NOTIFICATION		
Service Bulletin #	JSA-N001-1	
Superseded Bulletin #	JSA=N001	
Issue Date	08/27/2009	
Effective Date	08/27/2009	
Limitations for Completion	At Owner / Operator Option	
Make & Model Affected	J250-SP Serial # 248 through 623	
	J230-SP Serial # 248 through 623	
	J170-SP Serial # 36 through 175	
Page 1 of 6

This issuance of JSN-001-1 is to put the superseded bulletin in the correct format as specified in ASTM F2295

The modification detailed in this Letter increases the current available to engine's starter motor, improving cranking speed and engine starting.

Figure 3: Alternate Cable Attachment

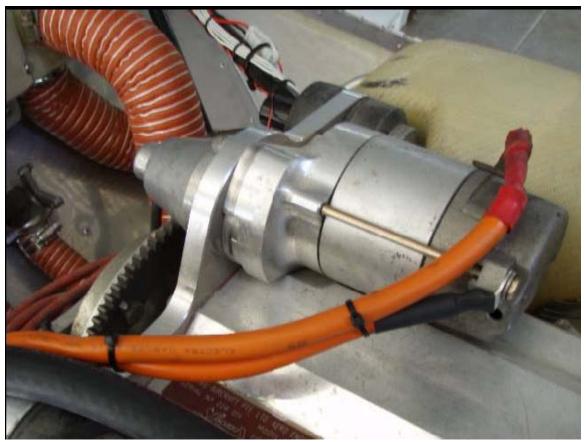
Figure 3 shows an alternate routing of the starter ground cable.

In the typical installation the motor's earth cable is connected to the backing plate of the engine. The modified installation connects the ground cable directly to the starter motor end cap.

- a) Remove the cable from under the cap screw on the engine backing plate or bolt on the alternator support bracket.
- b) Re-fit the cap screw to the engine backing plate or bolt to the alternator support bracket. A washer must be fitted underneath the head of the cap screw or bolt.

- c) Before installing, clean any grime or corrosion off the mating surfaces of the motor and the cable to ensure a good electrical connection
- d) As this is a 3/16th bolt a AN960-416 washer under the head of the bolt is required to ensure good contact with the ground cable end terminal.

- e) Remove the bolt that holds the starter body together and clean the thread of the starter motor through-bolt, removing old Loctite.
- f) Fit the AN960-416 washer on the bolt and then the cable under the head of the bolt that holds the starter body together. Apply a small amount of Loctite 242 (approximately the size of a match head) or equivalent to the starter motor through-bolt thread on reassembly.

- g) It may be necessary to cut some cable-ties and re-route the cable slightly to gain sufficient length to reach the end of the starter motor.
